AMENDMENT OF SOLICITATION/MODIFICATION OF CONTRACT			1. CONTRACT ID CODE	PAGE OF PAGES	
			J	1	9
2. AMENDMENT/MODIFICATION NO. 0006	3. EFFECTIVE DATE 17-Nov-2003	4. REQUISITION/PURCHASE REQ. NO. W81G67-3036-4923		5. PROJECT NO.(If applicable) DACW37-03-B-0007

SUMMARY OF CHANGES

EAST GRAND FORKS - PHASE 3
DRAWING INDEX
REFERENCE DRAWING INDEX,
LEGEND & GENERAL NOTES

DRAWING NUMBER:
R-P-GF-
64/1620
SHT 65 OF 188

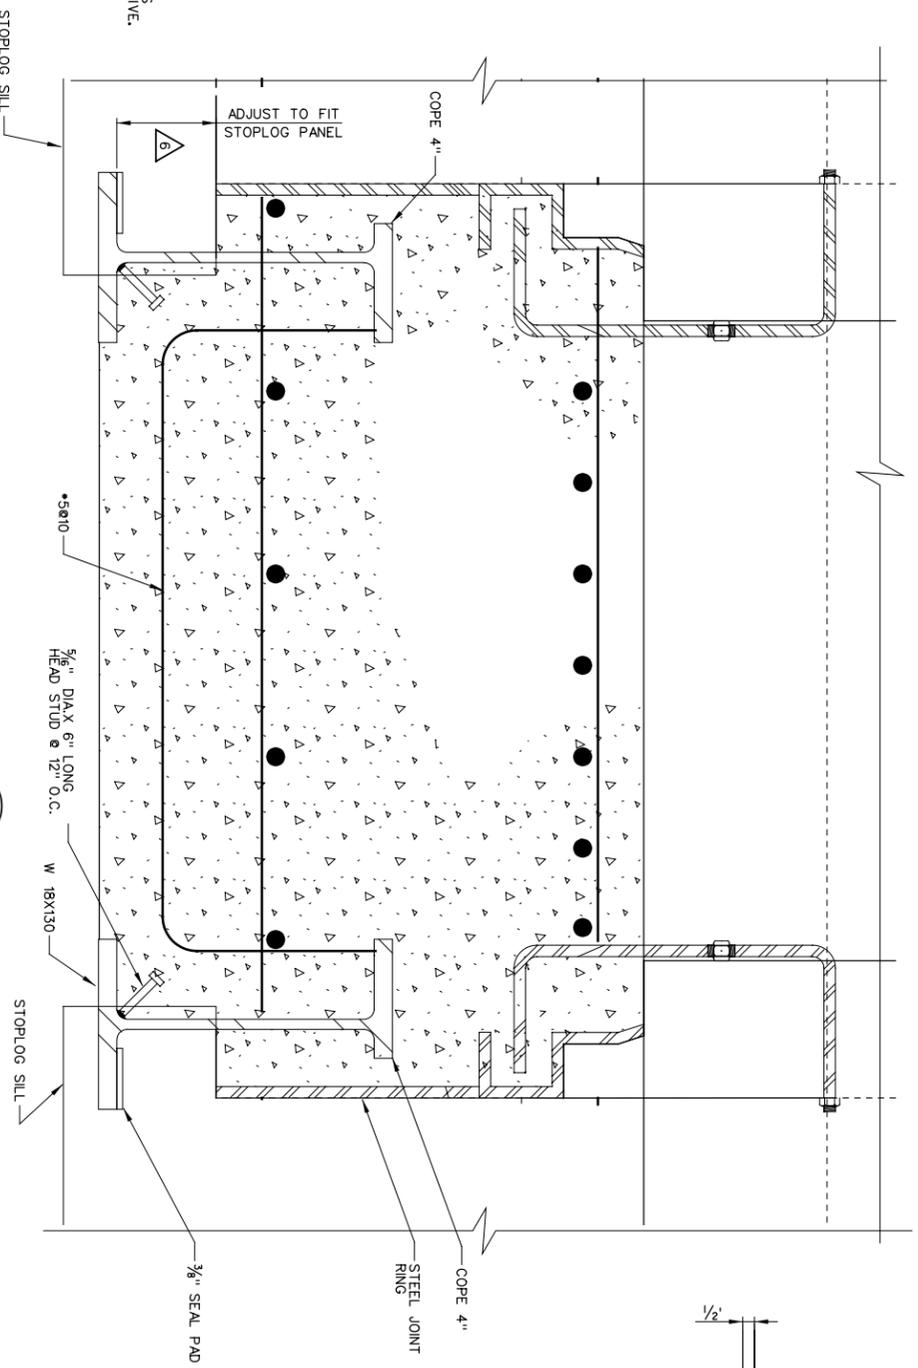
Drawing:	Summary of changes:
00/044	Updates Reference Drawing Index.
64/1620	Replaces L8 gatewell stop logs with Stop log panel.
64/1622	Adds L8 gatewell design requirements for stop log panels.
64/1645	Replaces L9 gatewell stop logs with Stop log panel.
64/1649	Replaces L10 gatewell stop logs with Stop log panel.
64/1652	Adds stop log panel design information.
64/1680	Changes overall dimension of pump station L6 superstructure.
64/1681	Changes roof type to “Bermuda metal roof”.
64/1682	Corrects Section A, Typical Section B, and Detail 2.
64/1683	Corrects notes on Details 1,2, and 3.
64/1685	Corrects note on sump pump access hatch.
64/1686	Changes monorail hoist spacing.
64/1687	Changes superstructure dimensions.
64/1697	Replaces L6 gatewell stop log details with stop log panel.
64/1698	Replaces stop log details with stop log panel details.
64/1714	Replaces L8 gatewell stop logs with Stop log panel.
64/1717	Corrects detail SLG for stop log panel.

DRAWING NUMBER:
R-P-GF-
64/1645
SHT 89 OF 188

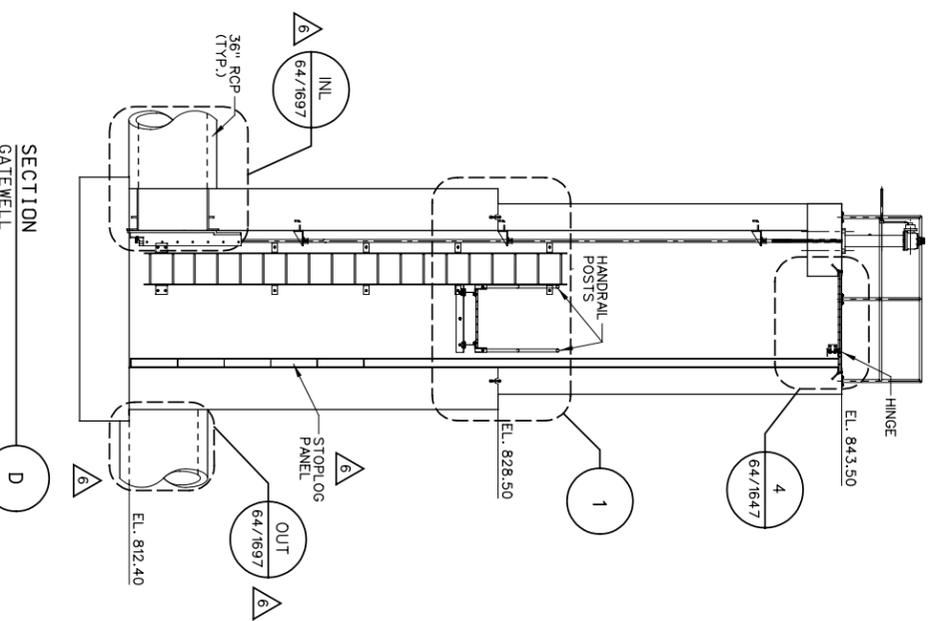
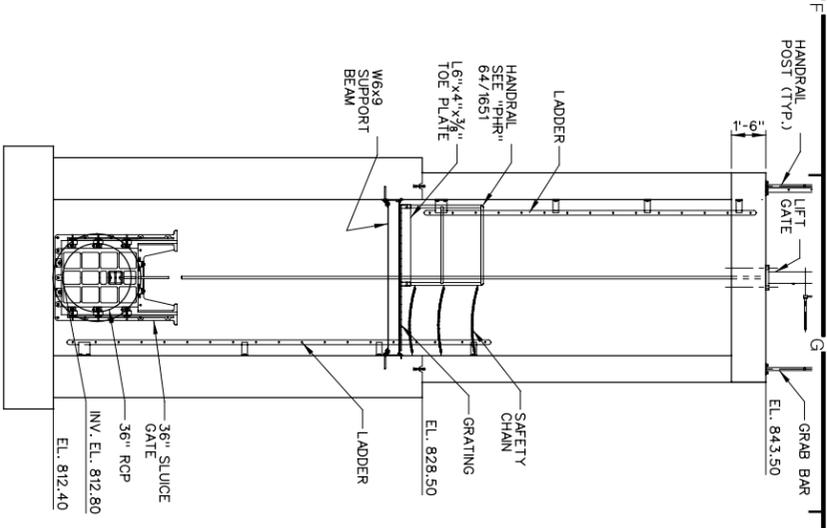
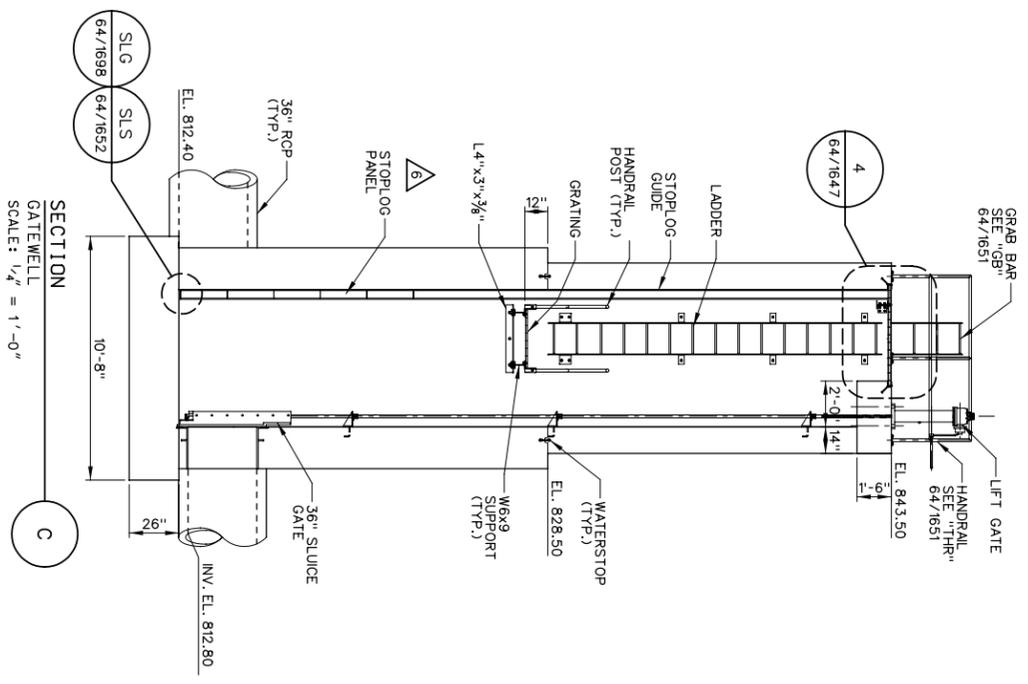
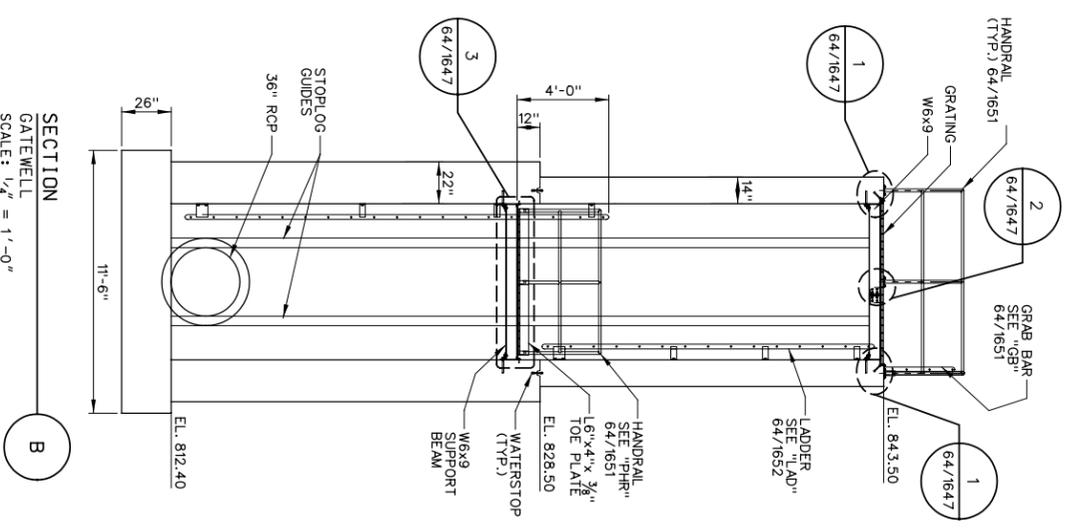
NOTE:
1. STOPLOG PANEL SEALS IN AN UNSEATING HEAD CONDITION.

DRAWING NUMBER:
R-P-GF-64/1649
SHT 93 OF 188

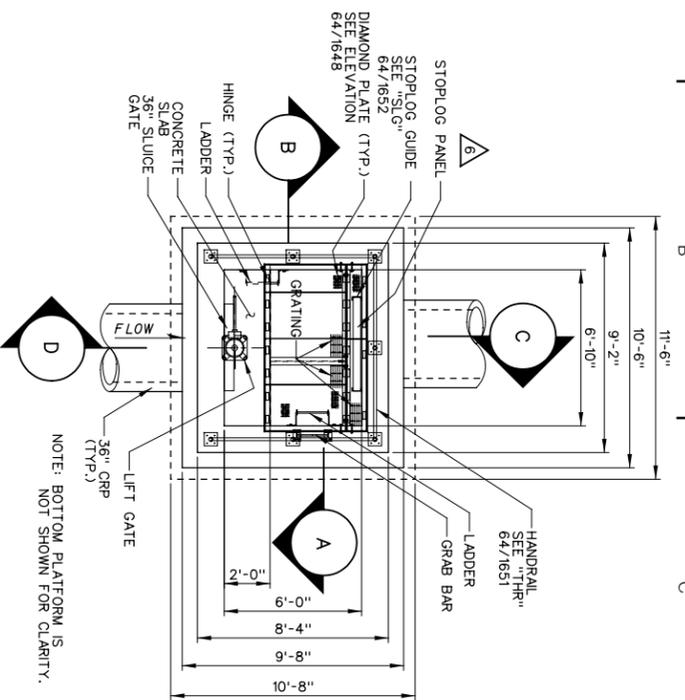
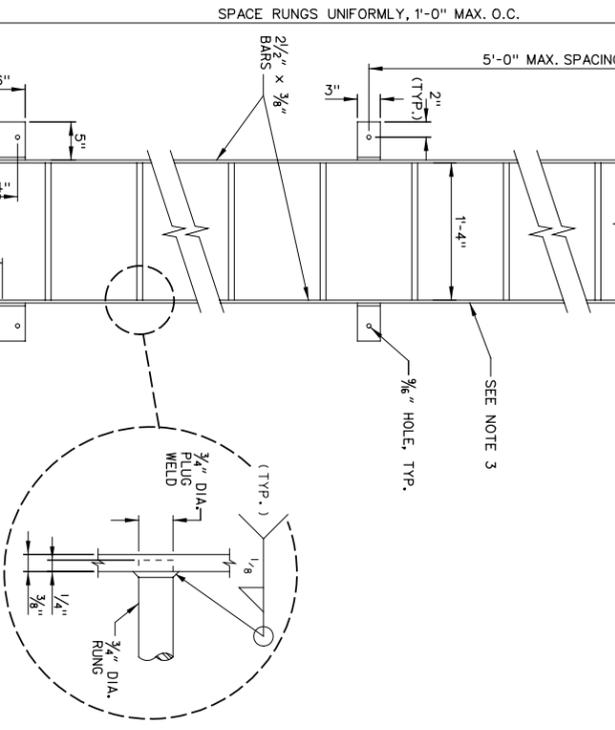
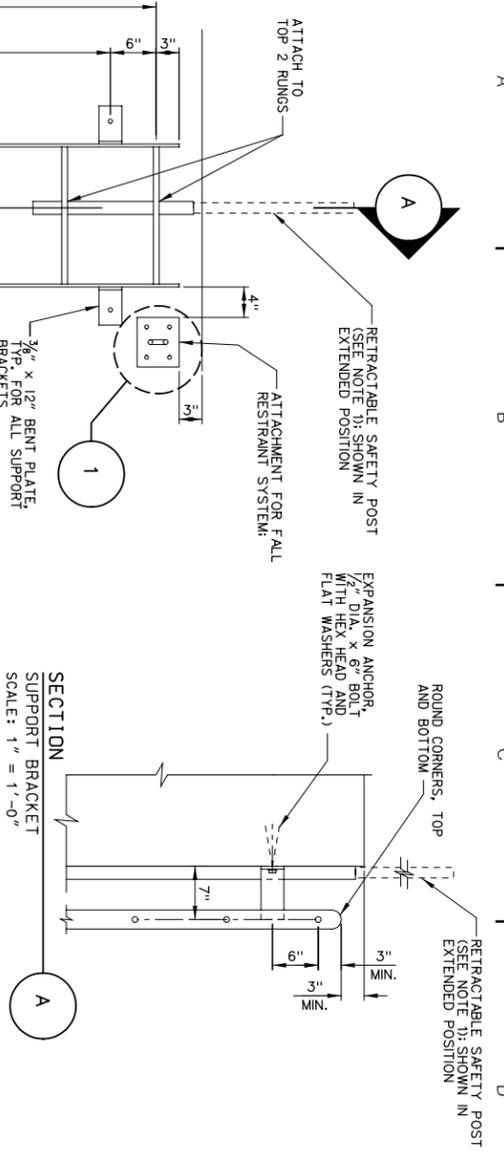
NOTE:
1. STOPLOG PANEL SEALS IN AN UNSEATING CONDITION.

DRAWING NUMBER:
R-P-GF-
64/1698
SHT 141 OF 188

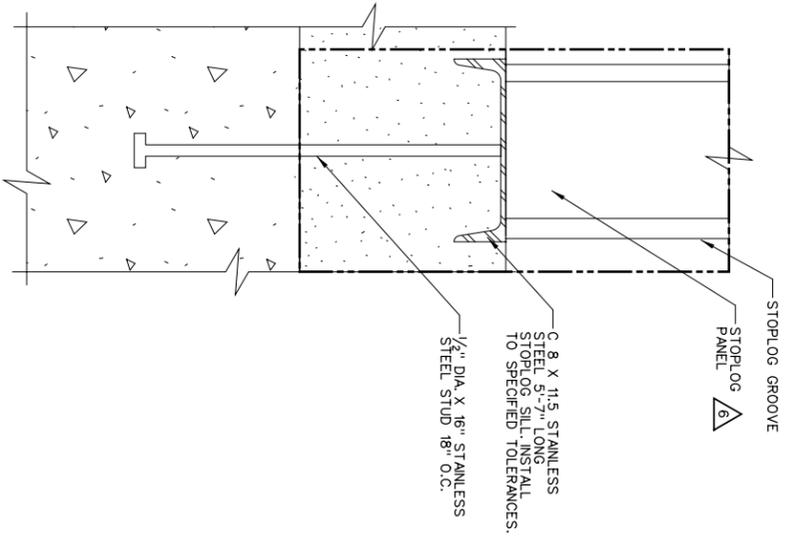
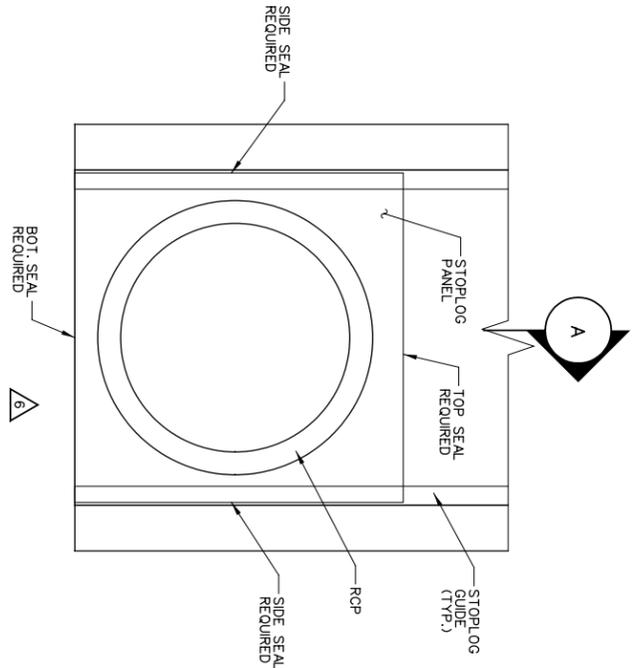
DETAIL
TYPICAL STOPLOG PANEL SEAL & GROOVE
SCALE: NONE
SLG
64/1645
64/1649
64/1714
64/1720

DRAWING NUMBER:
R-P-GF-64/1720

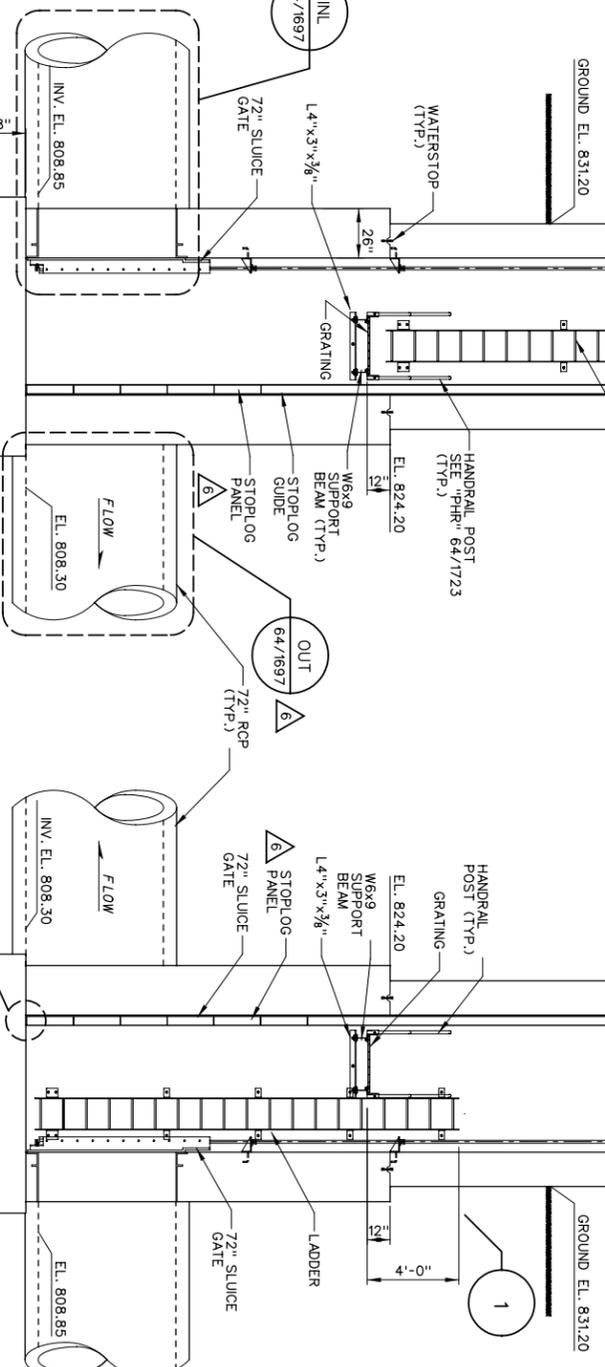
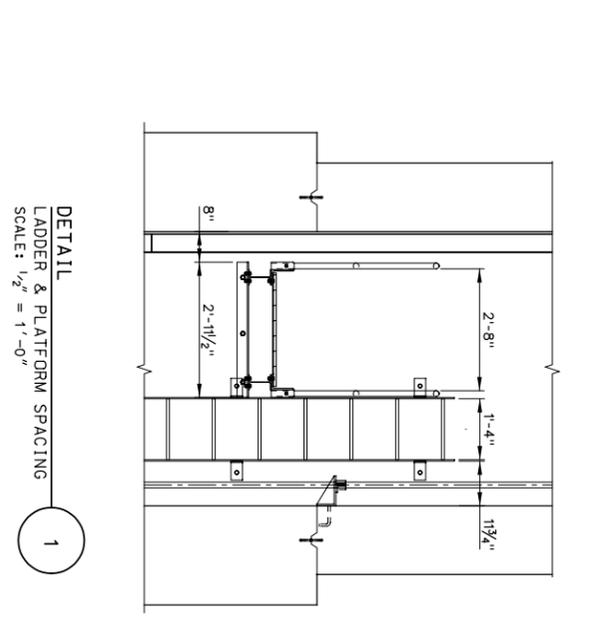
64/1720	Replaces L3 gatewell stop logs with stop log panel requirements.
